Planning Commission

Tuesday, October 17, 2023

STAFF REPORT

Agenda Item # 6a: Preliminary and Final Plat Review for a Condominium Plat

DEEPWATER GRILL CONDOMINIUM

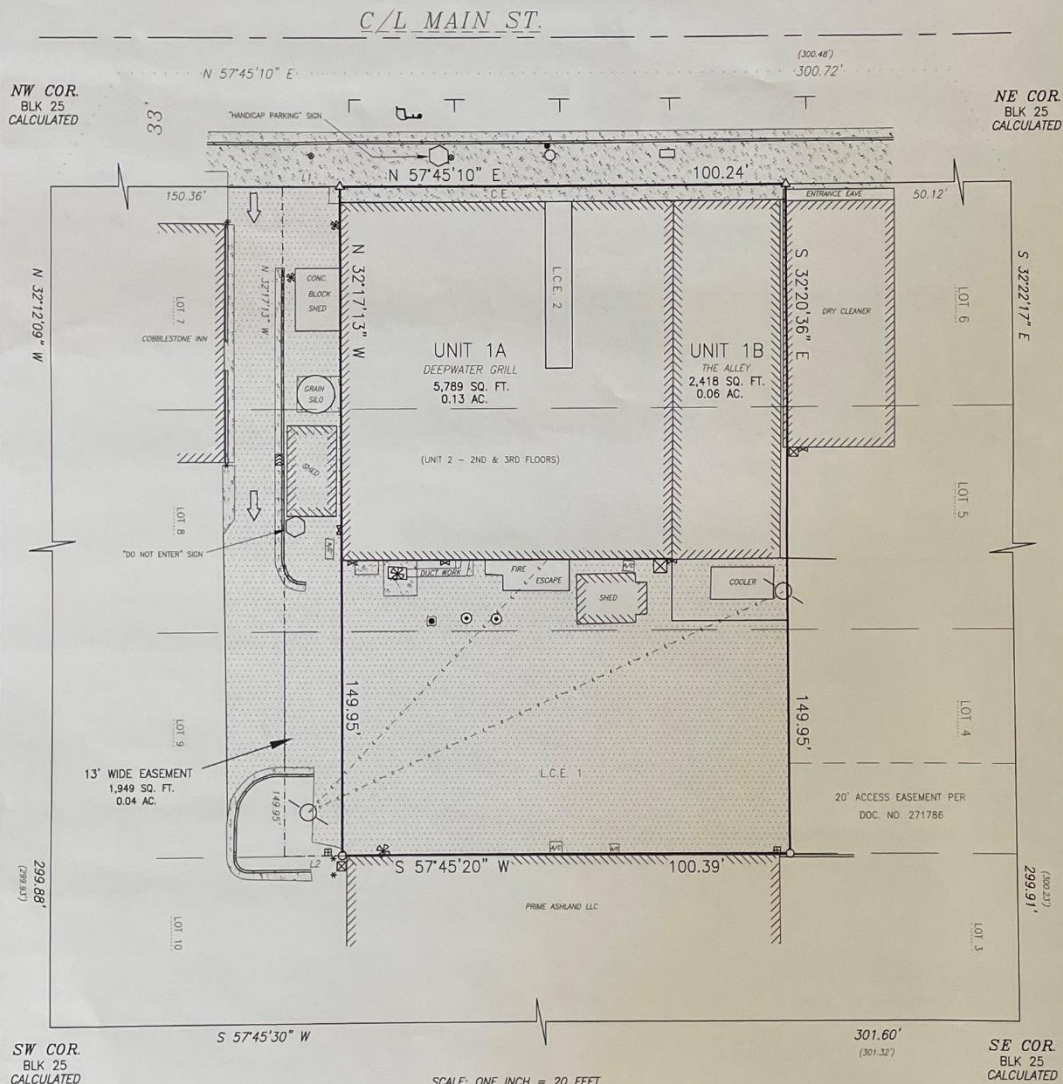
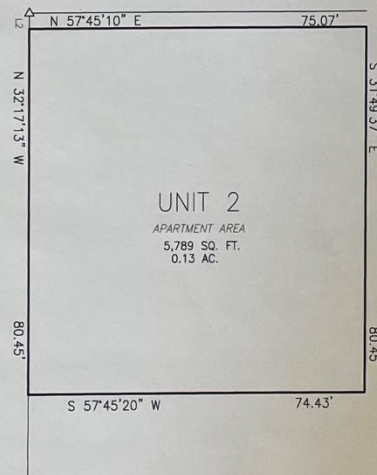
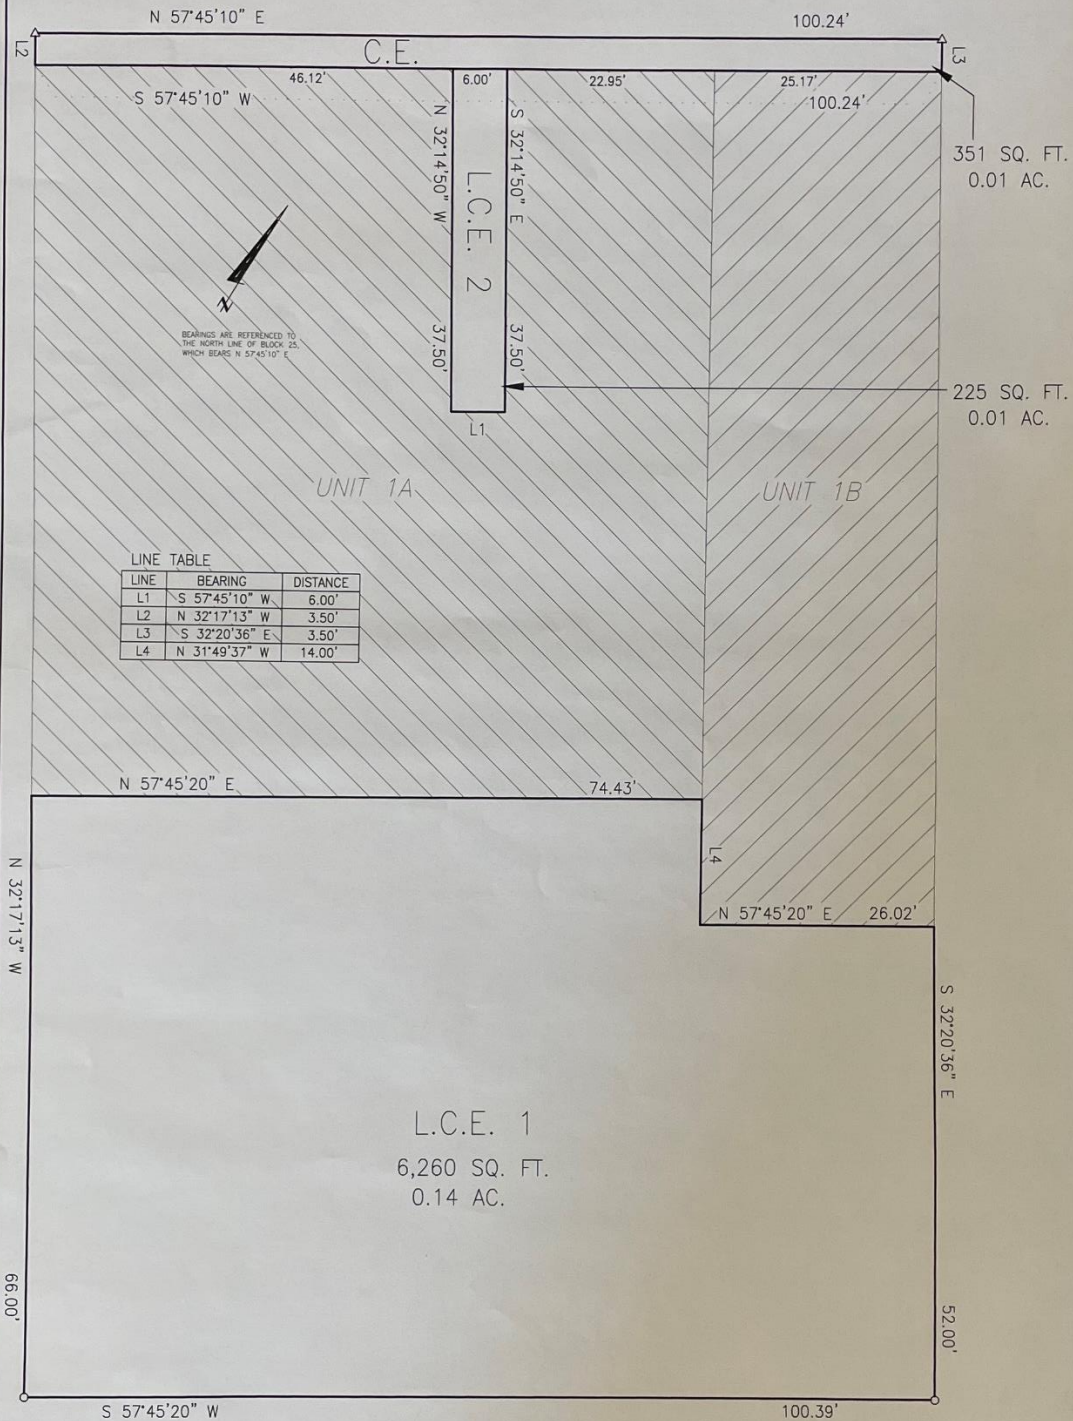
The applicant submitted a complete application with the draft Condominium Plat and explained the reasoning for the proposed Condominium Plat. The Plat itself has the information necessary for staff, the Plan Commission, and the Common Council to review. The plat was drawn by a licensed surveyor and has a legal description, legend, scale, details, and areas of the portions of the subject property to be split into condominium units. Identification of each unit and common elements of the property are clear in the proposed Plat.

Planning staff has forwarded on the draft plat to the Public Works Director, Fire Chief, Police Chief, and Wastewater Operations Manager. The Fire Chief and Police Chief do not have concerns with the Condominium Plat as proposed. The Public Works Director explained that his only concern would be water metering so staff is seeking input from the Water Utility. Staff also inquired with the Wisconsin Department of Administration (DOA) on whether a DOA review is required. The DOA informed staff that they do not review condominium plats so nothing needs to be sent to them.

Staff recommends Preliminary and Final Plat APPROVAL of the Condominium Plat proposed for the 806 and 808 Main Street West properties contingent on the following conditions:

- Applicant to meet any requirements of the Water Utility and any other utilities for metering.
- Applicant to submit a copy of the recorded plat to City staff once it is recorded at the Ashland County Register of Deeds.

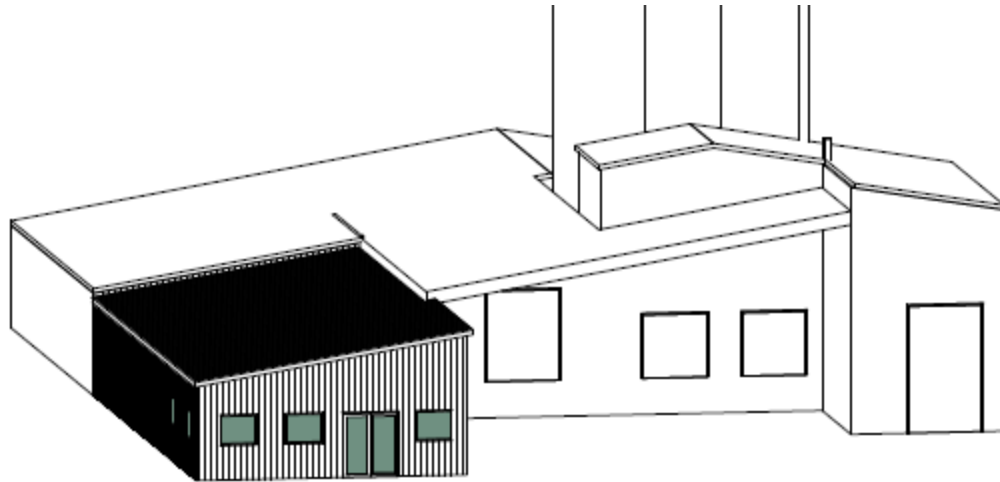
The applicants have proposed some additional light fixtures as part of the project. Examples are shown in the above image submitted by the designer. The designer explained a need to illuminate the site to prevent break-ins and other issues due to the secluded nature of the site. The proposed light fixtures are wall packs to be mounted on the building. The applicant has not yet submitted a lighting plan showing illumination levels onsite. A lighting plan is required in most cases if the applicants propose changes to on-site lighting fixtures. Any new light fixtures would need to comply with current lighting standards. Staff would recommend as a condition of approval that the applicants submit a photometric plan showing light levels in the areas where the new light fixtures are proposed.

4. The applicant shall submit a code compliant lighting plan showing proposed illumination levels in the vicinity of planned new or revised light fixtures to Planning staff for review and approval prior to installing lighting onsite.

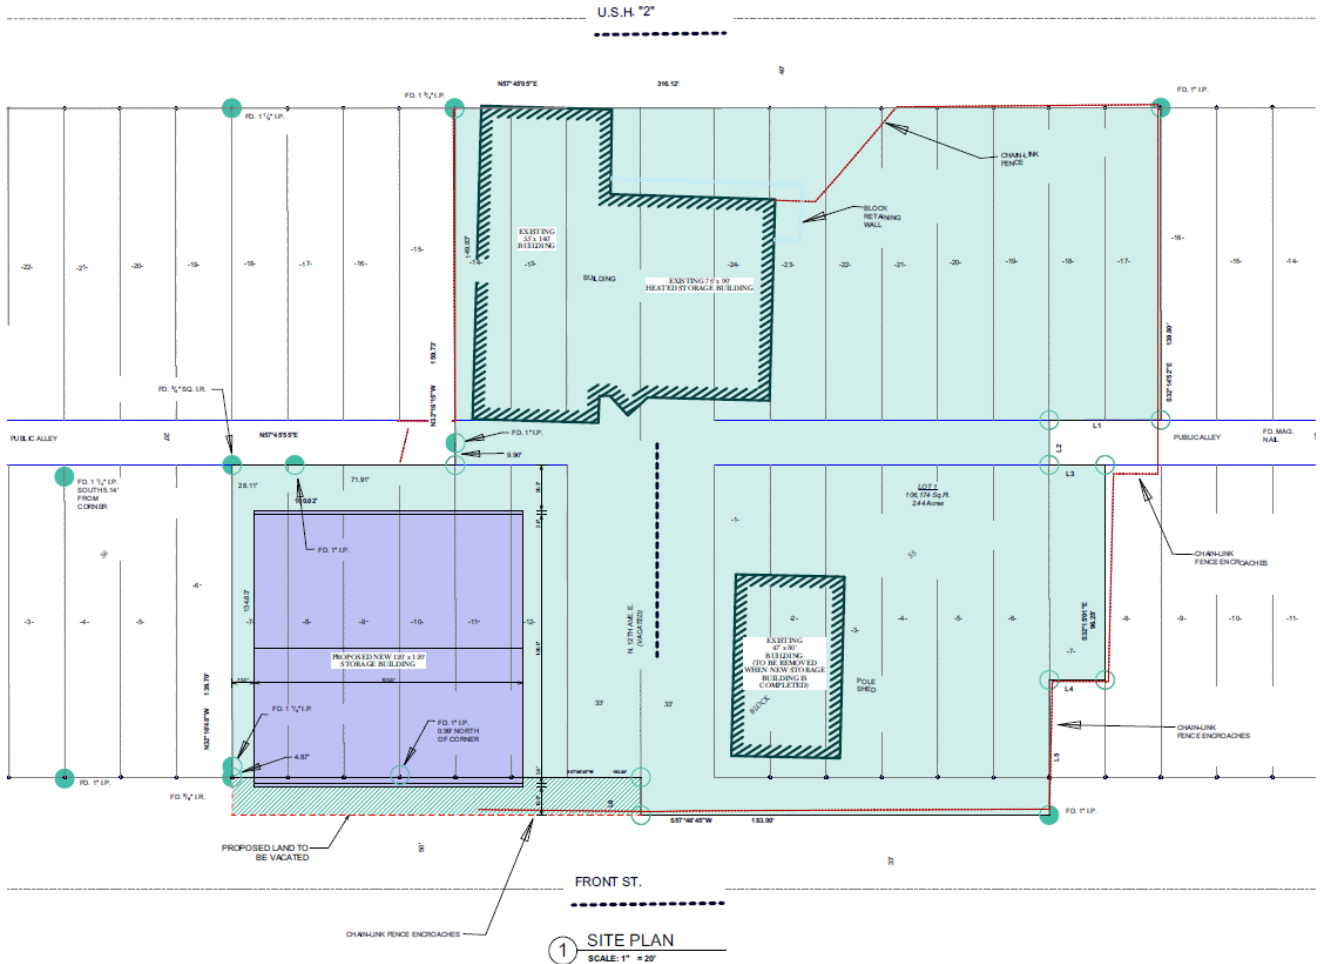
Above is the site plan submitted by the applicant. The storage building is planned for the southwest corner of the site. The existing storage building to the east would be demolished upon completion of the new building.

No changes are proposed to the parking adjacent to the building off of Lake Shore Drive. Much of the 1120 Lake Shore Drive parcel not currently covered by buildings is fenced in area used for equipment storage. Staff would recommend as a condition of approval that the applicant remove an amount of existing building and/or gravel area equivalent to the area to be disturbed with the construction of the new building or at least enough impervious to hit the 70% maximum impervious ratio. This would require changes to the site plan and staff would recommend requiring that the applicant make revisions to the existing site plan and submit a revised site plan reflecting the changes required.

No significant grading changes are anticipated. If the applicant would add the proposed storage building without removing impervious surface (gravel and/or building area) this could cause drainage and stormwater runoff issues. Staff has concerns with the plans as proposed and would recommend requiring revisions (mentioned in the Parking and Storage Areas section above). The UDO allows for a slight increase in impervious surface ratio (75% versus 70% if the applicants implement stormwater management features).

The main environmental issue would result from adding impervious surface area to the site without removing enough existing impervious. Staff has concerns with the plans as proposed for this reason. Currently other than the planned removal of the existing storage building the applicant has not shown plans to remove existing impervious area on the site. Staff would recommend a condition requiring the removal of an amount of existing impervious equivalent to the amount of area to be disturbed by the construction of the new building or enough existing impervious to ensure the combined site is not over the 70% impervious surface maximum (or 75% if stormwater management/runoff features are implemented).

The applicant does not show landscaping or screening in the plans provided. Typically, the UDO Landscaping standards require one tree and two shrubs for every 2,000 square feet of site disturbance for a new accessory building. Additionally, a 30-foot wide landscape buffer is required between industrial uses and adjacent residential properties. Staff would recommend as conditions of approval that the applicant submit a code-compliant landscaping plan and species list. Staff would also recommend that the Plan Commission require the 30-foot wide landscape buffer between the proposed storage building and residential to the west. Staff would require a revised site plan showing this buffer and indicating dimensions.

6. If the Fire Department requires any fire prevention measures the applicant shall implement these as required.
7. Applicant must demolish the existing accessory storage building and remove it and existing impervious surface area (building, pavement, or gravel) equivalent to the area to be disturbed for the proposed storage building or remove enough existing impervious to ensure that the site does not exceed 70% impervious surface (or 75% if acceptable stormwater management/runoff features are approved and implemented) for the overall site upon completion of the proposed accessory storage building. Applicant shall update the site plan to show the location of the impervious areas to be removed and submit the revised plan with impervious area calculations to Planning and Development staff for review.

8. Applicant shall submit a code compliant landscaping plan and schedule for staff review prior to conducting work onsite.
9. Applicant shall submit a design for an acceptable 30-foot landscape buffer between the proposed storage building and the adjacent residential properties to the west. Applicant shall also update the site plan to show the 30-foot buffer and dimensions and submit the revised plan to Planning and Development staff for review.

① WEST ELEVATION
SCALE: 3/16" = 1'-0"

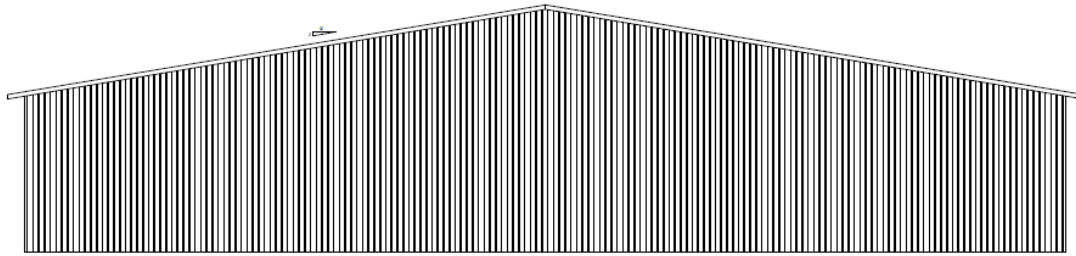
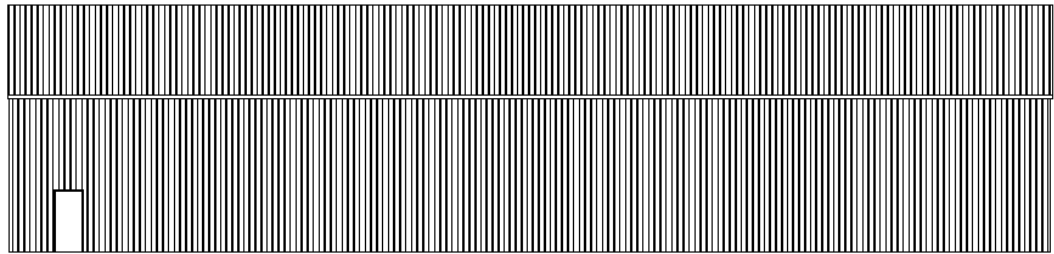
The applicant has submitted elevations for the proposed storage building. The elevations show the building having a gable roof and four garage doors for vehicle access on the east elevation. Two service doors are shown on the east elevation and one service door on the north and south elevations. The elevations submitted show the building to be clad in ribbed steel siding similar to siding used on KBK's other buildings on the property. Staff has communicated to the applicant that there are concerns with the ribbed steel siding

proposed on the west and south elevations. The west elevation will face adjacent residential land uses immediately next to the KBK property and the south elevation will face Front Street and be highly visible in the neighborhood. The applicants have indicated that they are willing to explore alternative cladding materials for the west and south facades. Staff would recommend as a condition of approval that the applicant submit revised west and south elevations showing code-compliant materials appropriate for the neighborhood.

10. Applicant shall revise the west and south elevations of the proposed storage building with a code-compliant material other than ribbed steel siding and submit the revised elevations for staff review prior to obtaining building permits.
